Service Bulletin

Bulletin No. 2016-11
OEM No. 2016-08

Power Steering Fluid Leaks—MerCruiser Sterndrive Engines

62455

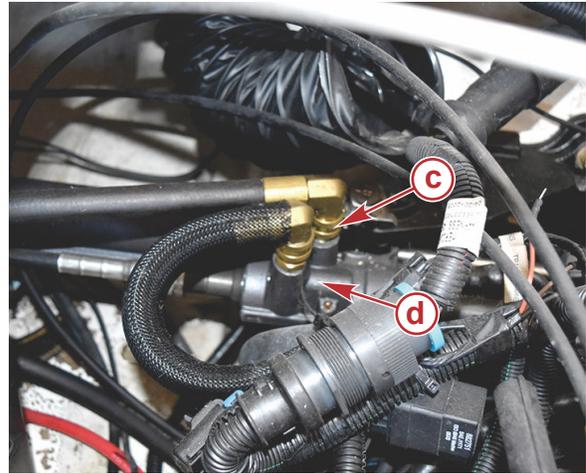
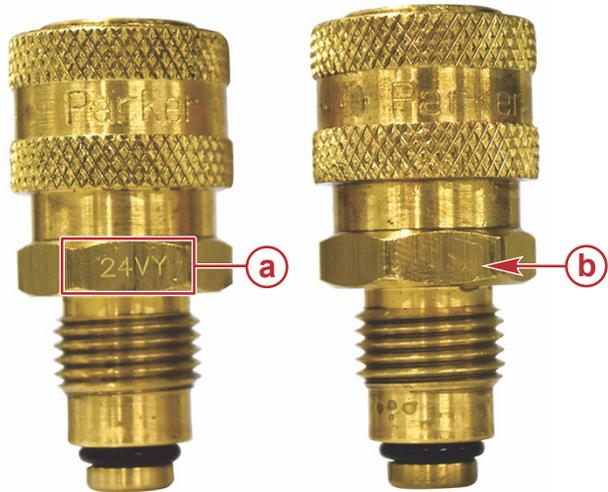
1. Inspect any inventory of power steering cylinder assembly kits for a power steering quick-connect return fitting without a date code. Refer to **Parts Affected** for the cylinder assembly part number. Follow the instructions in the **Warranty** section of this bulletin, and return kits that do not have a date code.
2. Inspect any loose inventory of power steering quick-connect return fittings for a date code. Refer to **Parts Affected** for the fitting part number. Follow the instructions in the **Warranty** section of this bulletin, and return any loose power steering quick-connect return fittings that do not have a date code.

NOTE: The date code is only visible on one flat of the fitting. Be sure to check all sides of the fitting while attempting to locate the date code.

- a** - Power steering quick-connect return fitting with date code
- b** - Power steering quick-connect return fitting without date code
- c** - Power steering quick-connect return fitting location
- d** - Power steering cylinder assembly

62454

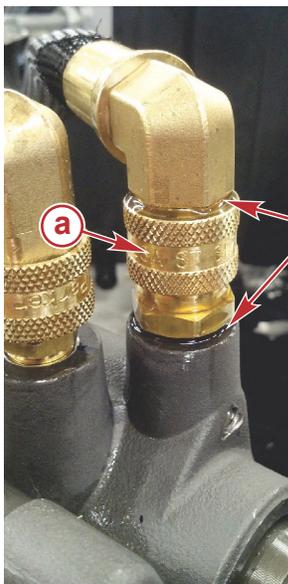
3. Inspect the power steering quick-connect return fitting on systems mounted in vessels. Run the engine if necessary. The presence of residual fluid around the fitting indicates a leak. If residual fluid is found, replace the power steering quick-connect return fitting.

- a** - Power steering quick-connect return fitting
- b** - Power steering residual fluid
